D3183-043

Bracket Assembly

DART AEROSPACE LTD	Work Order:	70799
Description: Bracket	Part Number:	D3183-3
Inspection Dwg: D3183 Rev: C1		Page 1 of 1

DRAWING NO). TITLE		, REV.C1	DART AEROSPACE LTD	I I a = a sia	<u> </u>	
D3183	· · · · · · · · · · · · · · · · · · ·	40001014	J KEV.CI J			SHEET NO.	SCALE
D3 103	BRACKET	ASSEMBLY		ENGINEERING ORDER	D3183-C1-1	SHEET 1 OF 1	NTS
DRAWN	q?	CHECKED		MFG. APPR.	APPROVED AM	DE APPR.	
DATE	10.05.14	DATE	10.06.30	DATE (0.06.30	DATE 10/05/30	DATE 10/06/30

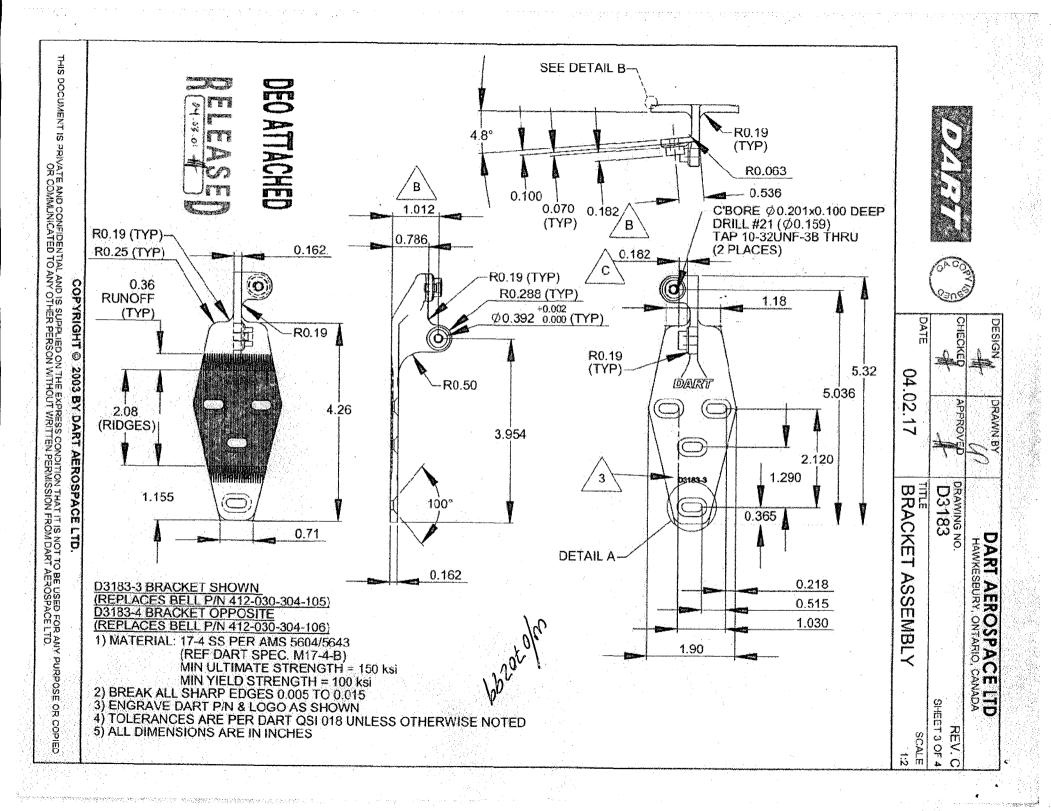
D3183-5 BEARING

ADD POSSIBLE SUPPLIER: KML P/N 6800-ZZ

BASIC LOAD RATING REQUIREMENT:

Cr = 1720 N (386 lb) MIN [DYNAMIC]

Cor = 840 N (188 lb) MIN [STATIC]
